Subject: FW: Grenfell Tower, Grenfell Road, Refurbishment - Fire Strategy P2

The Building Regulations 2010 [as amended] Grenfell Tower, Grenfell Road. London. W11.

Please find attached marked up plans and observations relating to the fire strategy for the Grenfell Tower project,

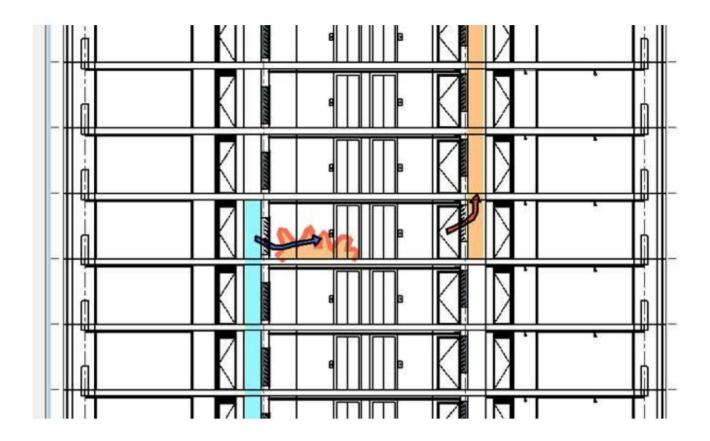
3. Principle of dual use of duct for vent and smoke okay – but not clear from document and would like some detail as to how this will be achieved.

The smoke controls and the temperature controls would all be part of the same control system controlling the dampers and the supply and extract fans.

Under normal conditions, all the dampers would be open and the system would operate as a natural ventilation system. Temperature sensors would be located on 'typical' (say 5 No.) lobbies. If the temperature in any of these areas exceeded a pre-set comfort level, then the supply and extract fans would operate to try to reduce the temperature.

In the event of smoke being detected within any lift lobby served by the smoke control system, the fresh air and smoke dampers serving that particular lobby would remain open and the supply and extract fans would operate. The fresh air and smoke dampers on all other levels would be closed. The system would be set up such that it was 'fail-safe' with priority always being given to the fire safety operation.
